Hawkesdale Wind Farm proposed wind turbine modification

Further to a request from ERM Pty Ltd (email 14 January 2021), we have undertaken a review of the endorsed and proposed Hawkesdale Wind Farm wind turbines. We confirm that our review of potential visual impacts arising from revisions to the endorsed wind turbine design has included a review of the Endorsed Development Plans and proposed wind turbine illustrations/elevations as provided by ERM.

Figure 1-
Hawkesdale Wind Farm endorsed
and proposed wind turbine overlay

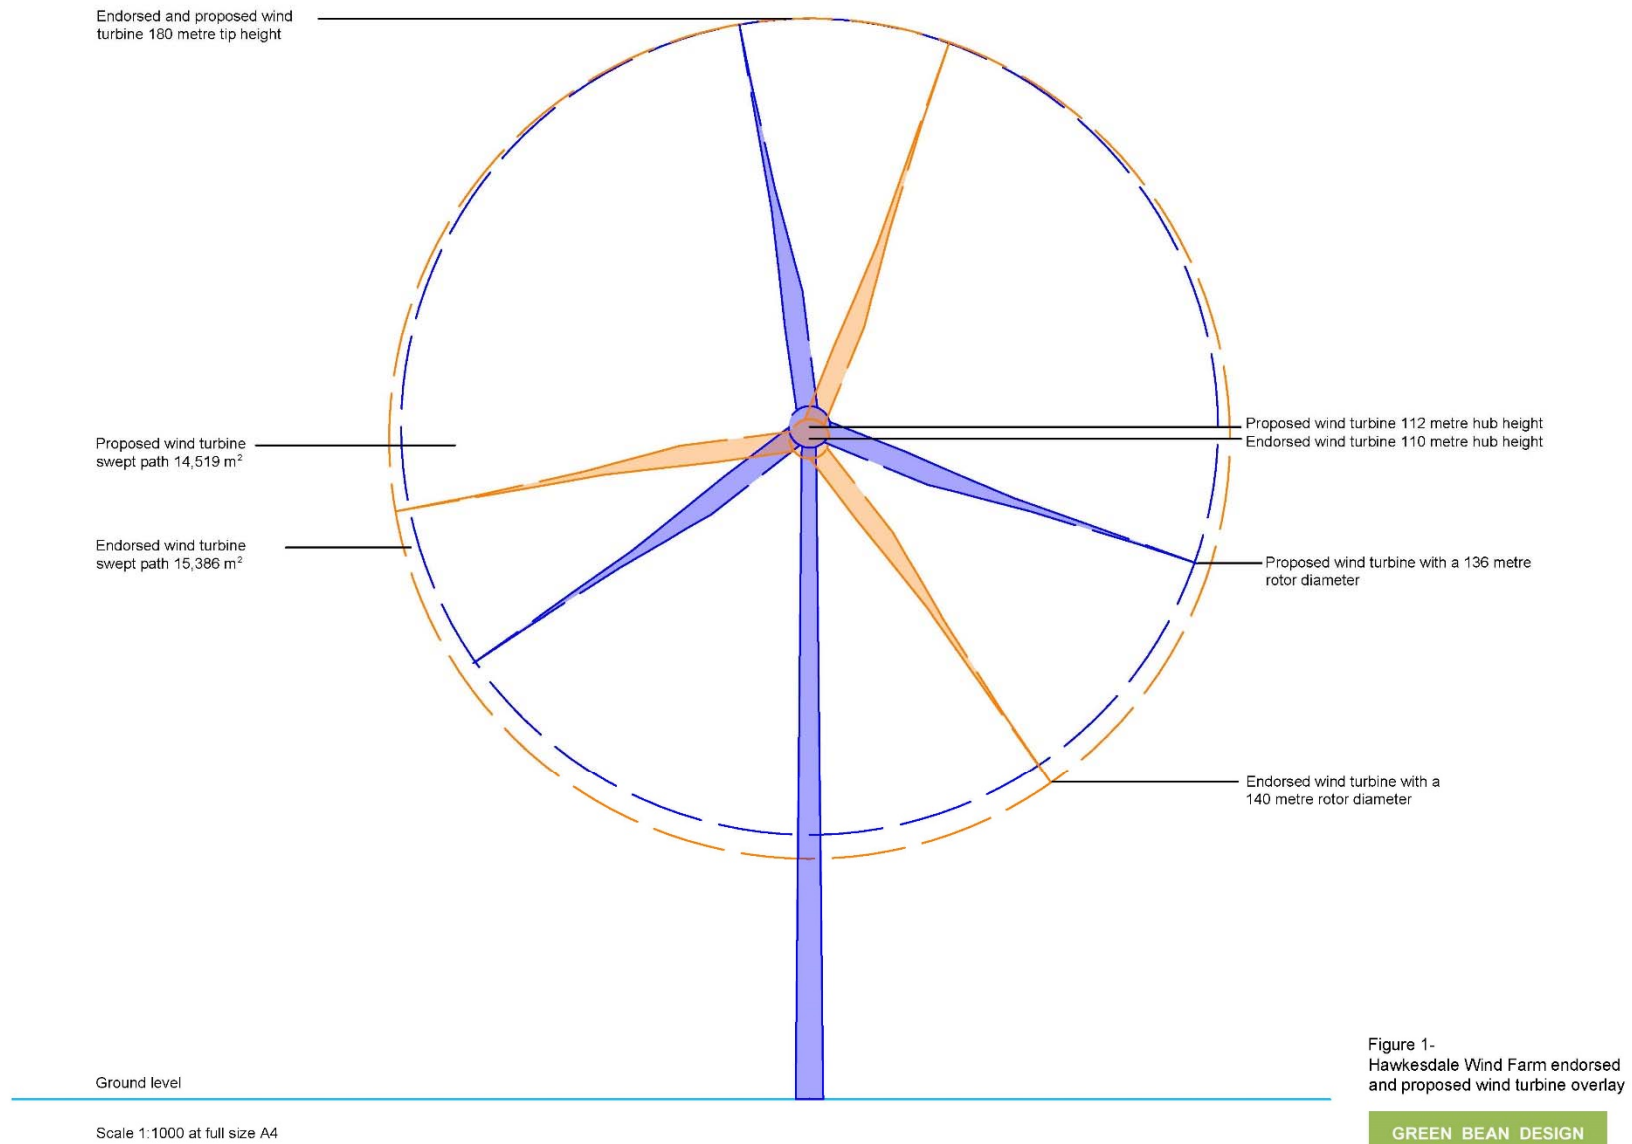
The endorsed wind turbine tip height at 180 metres would remain unchanged. An overlay of the endorsed and proposed wind turbine is illustrated in **Figure 1**.

The endorsed wind turbine swept path of 15,386 m² would be reduced to 14,519 m² (a reduction of 867 m² and percentage difference of - 5.6%).

Considering the above design criteria, and as illustrated in the endorsed and proposed wind turbine overlay (refer **Figure 1**), it is highly unlikely that the proposed wind turbine will result in any degree of increased

visibility or additional visual impacts upon surrounding key significant view locations. We specifically note the unchanged wind turbine tip height and the proposed wind turbine reduction in swept path.
